TOWN OF JACKSON PLANNING & BUILDING DEPARTMENT

TRANSMITTAL MEMO

The applicant is submitting a request for a Minor Deviation to revise the Development Plan for the property located at 112 Center St and 165 E. Deloney Ave.

Re: The Center Street Project (P17-213)

FDP APPROVED

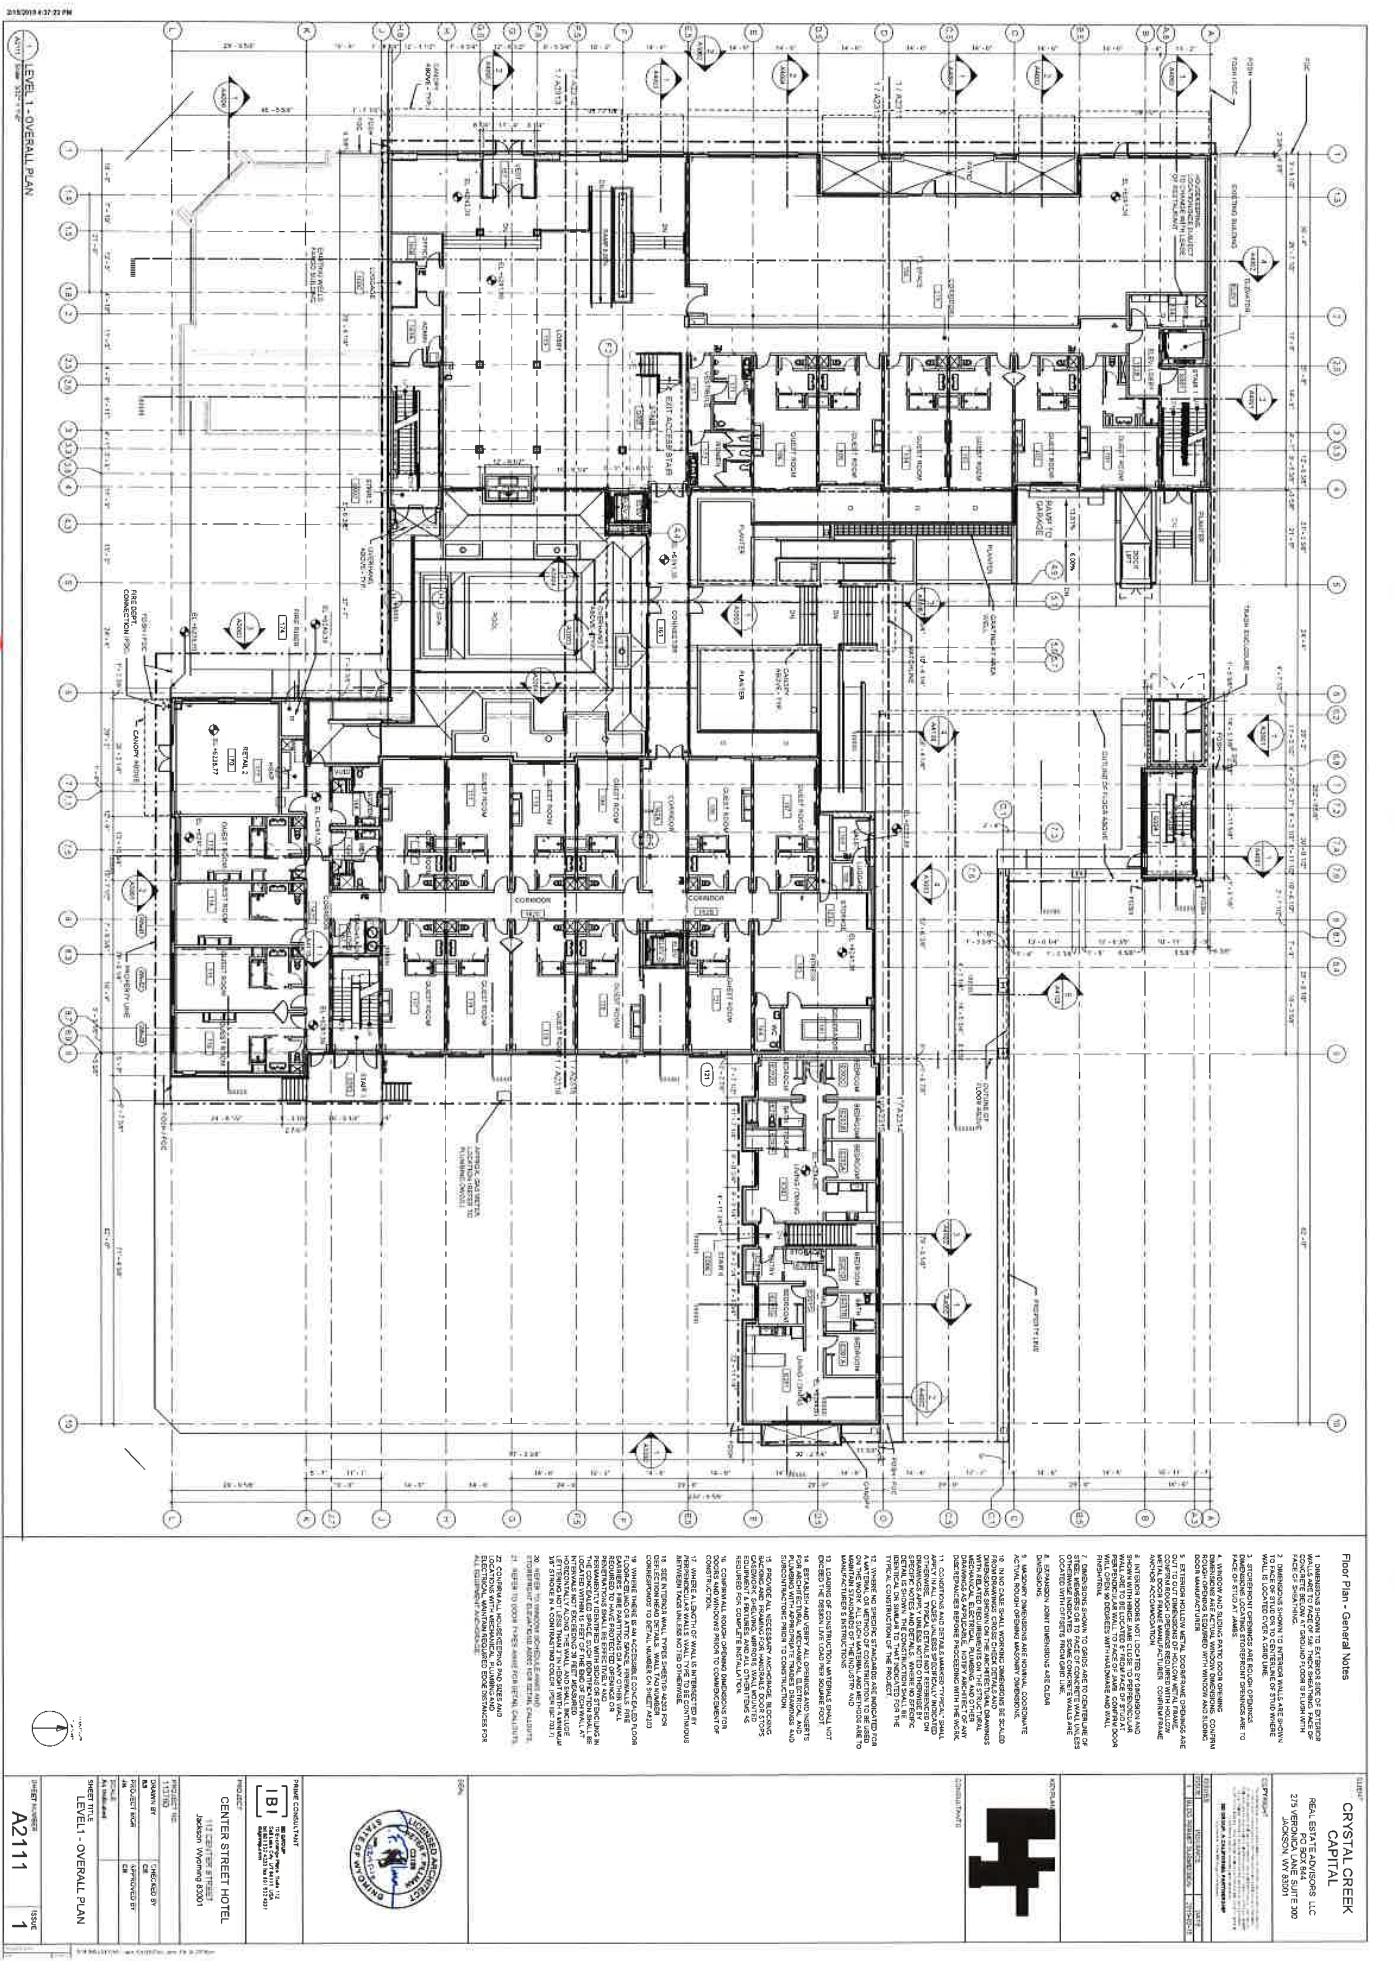
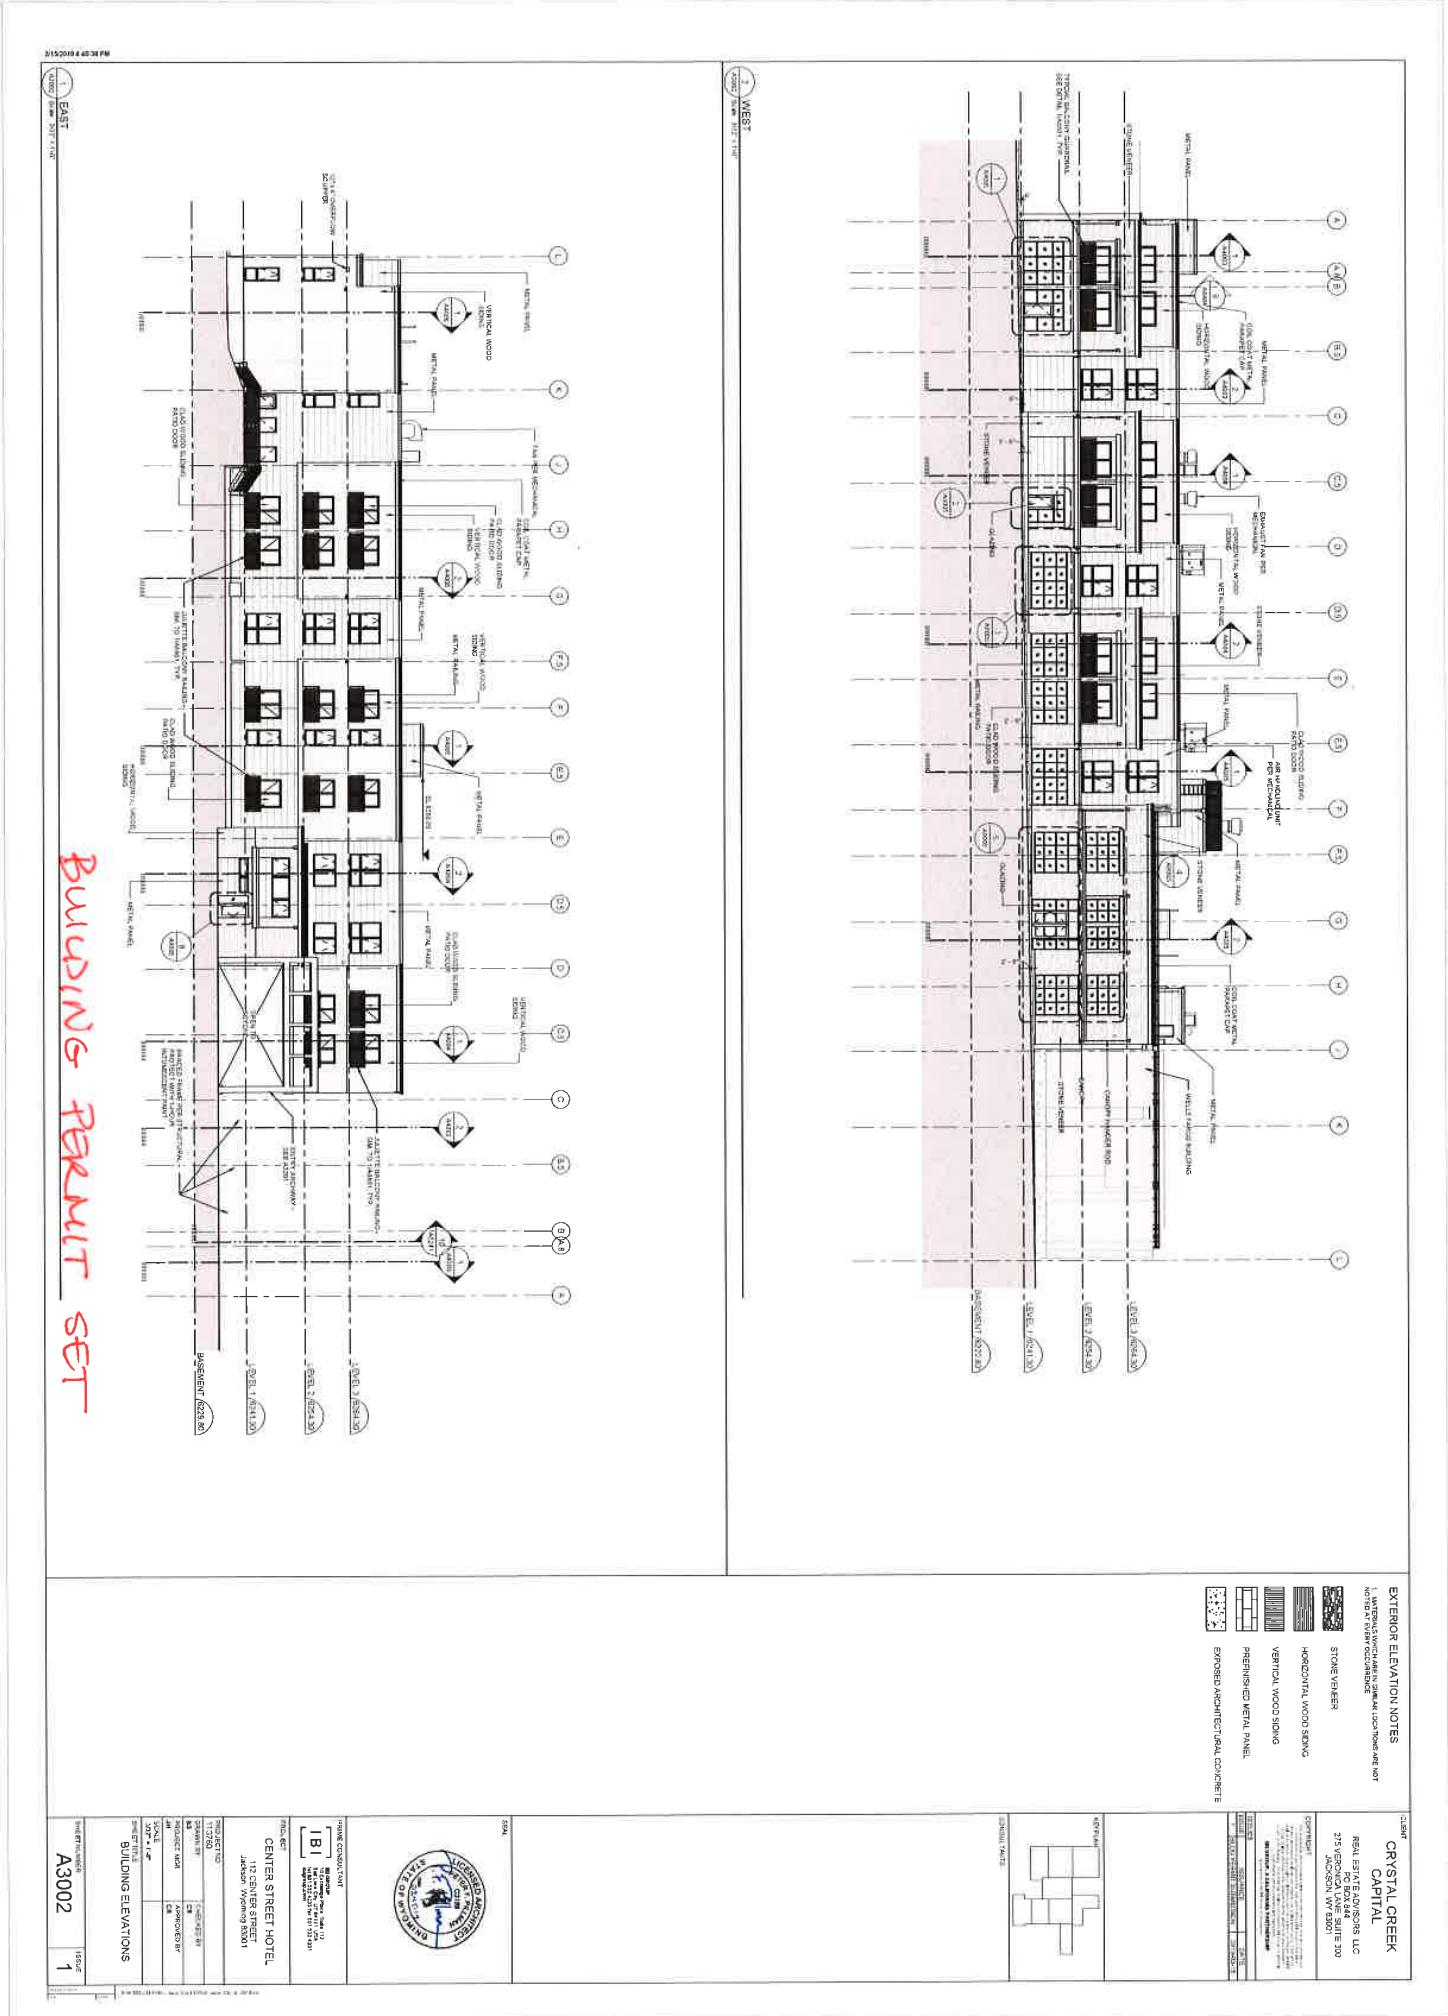
- The lobby size square footage increased from 3,518 sf to 3,881 sf. The increase in square footage to the lobby allows for improved circulation to facilitate the various uses of the public including the registering of guests staying at the hotel, restaurant and bar patrons and conference/meeting space patrons.
- Matching the sidewalk grade and the lobby grade has avoided the need for external steps and a handicap ramp but created the need for internal steps and a ramp. The increase in square footage provides a more accessible location within the lobby for a ramp.

- The restaurant will now provide breakfast, lunch and dinner, rather than one meal per day. While this provides an increase in service and patronage throughout the day it also increased the restaurant requirements due to the additional volume. It was determined the space would not be adequate and has increased from 3,251 sf to 3,709 sf.

- The retail space along Deloney Avenue was 558 (scaled from PDF) sf at FDP and increased to 620 sf at Building Permit.
- The retail space was removed from Center Street to allow for the increase in lobby size, the increase in kitchen and restaurant space and the opportunity to increase the offerings to a three-meal restaurant.

- The elevations of the project have not been affected by the proposed change. Included in the application is the FDP approved Elevation and the Building Permit submittal elevations.
- Also included in the application is the FDP approved floor plan and the Building Permit submittal floor plan.
